# TECHNICAL INFORMATION

**SUBJECT:** Backpack harness, Clip and Backpack frame  
on ECHO PB-760LN, PB-770 and shindaiwa EB770

**Number:** Y2018-650  
**Issued:** Jul. 31, 2018  
**Revised:** Mar. 29, 2019

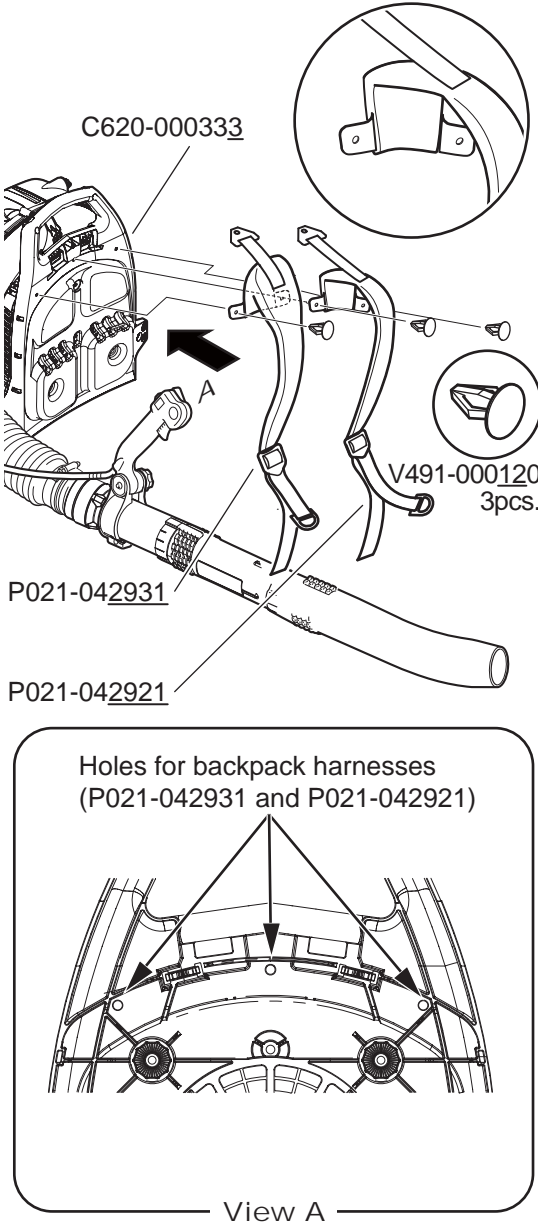
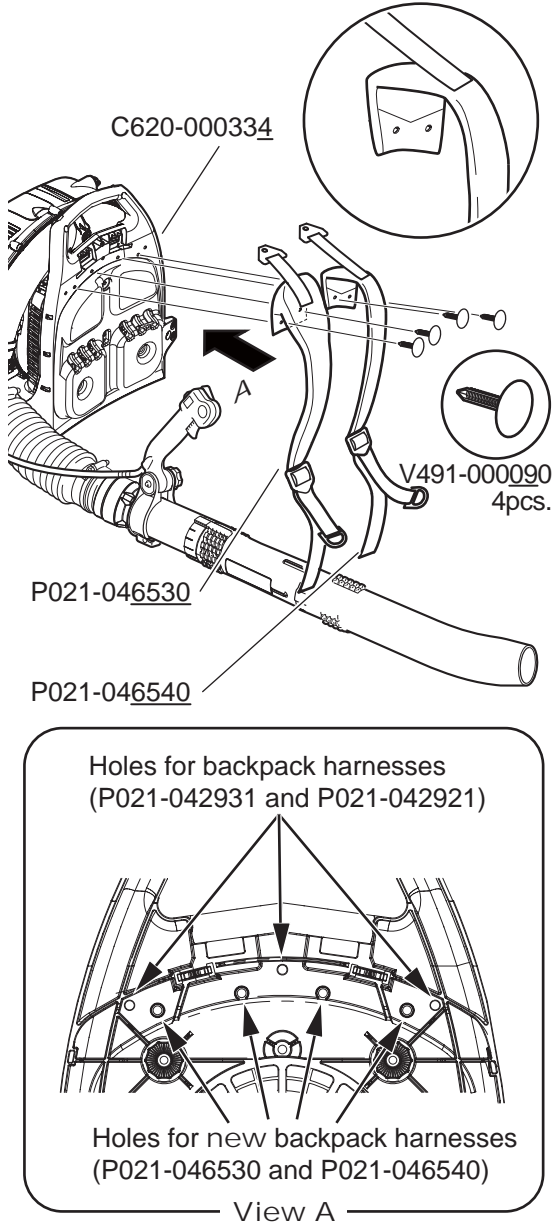
Backpack harness and clip are changed to improve durability.

PB-760LN (37)	Serial Number 37002667 and before	Serial Number 37002668 and after
PB-770 (37)	Serial Number 37028226 and before	Serial Number 37028227 and after
<p>Backpack frame</p> <p>Clip</p> <p>Backpack harness (For right shoulder)</p> <p>Backpack harness (For left shoulder)</p>	 <p>Holes for backpack harnesses (P021-042931 and P021-042921)</p> <p>View A</p>	 <p>Holes for backpack harnesses (P021-042931 and P021-042921)</p> <p>Holes for new backpack harnesses (P021-046530 and P021-046540)</p> <p>View A</p>
<p>Backpack frame C620-000333 can be replaced with C620-000334. A set of backpack harness P021-042931 and P021-042921 should be used with the clip V491-000120. A set of new backpack harness P021-046530 and P021-046540 and clip V491-000090 should be used with the new backpack frame C620-000334.</p>

**TECHNICAL INFORMATION Number: Y2018-650 (2/2)**

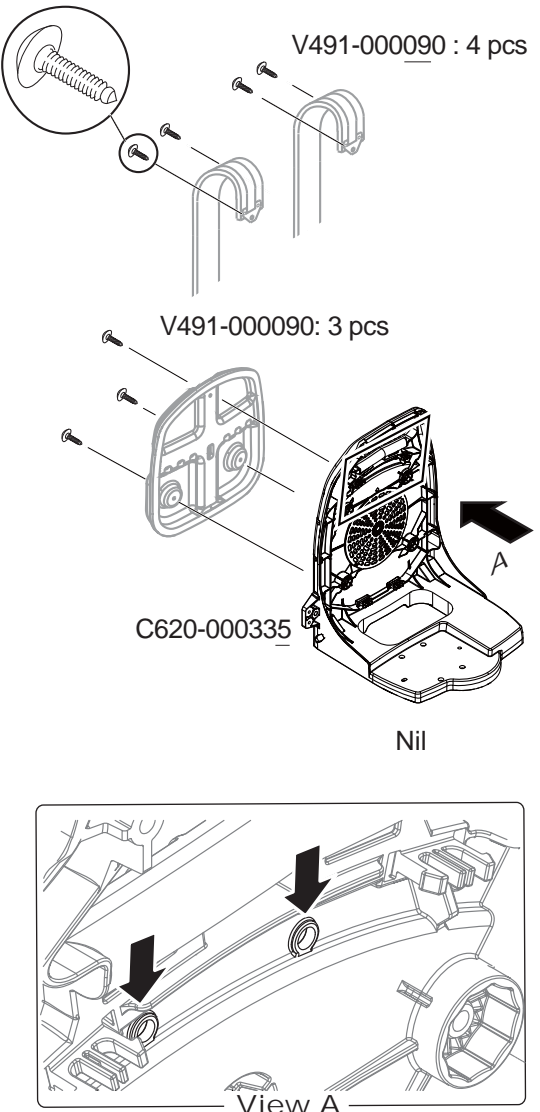
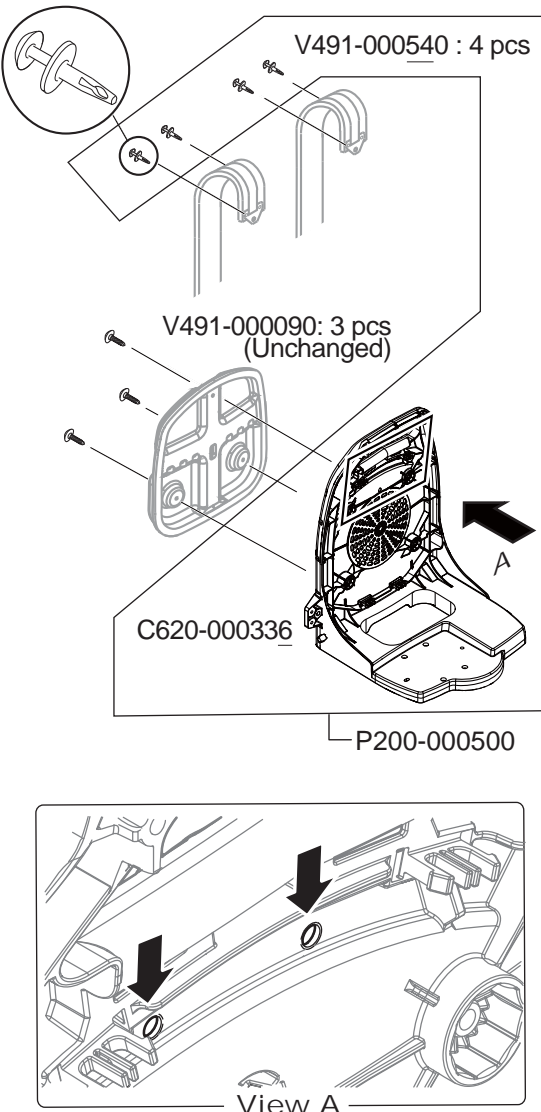
Clip is changed to make clip hard to come off from backpack frame.

PB-760LN (37)	Serial Number 37003556 and before	Serial Number 37003557 and after
PB-770 (30)	Serial Number 30001964 and before	Serial Number 30001965 and after
PB-770 (37)	Serial Number 37055403 and before	Serial Number 37055404 and after
EB770 (37)	Serial Number 37002200 and before	Serial Number 37002201 and after
<p>Clip</p> <p>Clip</p> <p>Backpack frame</p> <p>Backpack frame kit</p>	 <p>V491-000090 : 4 pcs</p> <p>V491-000090: 3 pcs</p> <p>C620-000335</p> <p>Nil</p> <p>View A</p>	 <p>V491-000540 : 4 pcs</p> <p>V491-000090: 3 pcs (Unchanged)</p> <p>C620-000336</p> <p>P200-000500</p> <p>View A</p> <p>A set of clip V491-000540 (4pcs) and backpack frame C620-000336 can be used on the unit before this change. Backpack frame C620-000335 is superseded by backpack frame kit P200-000500.</p>
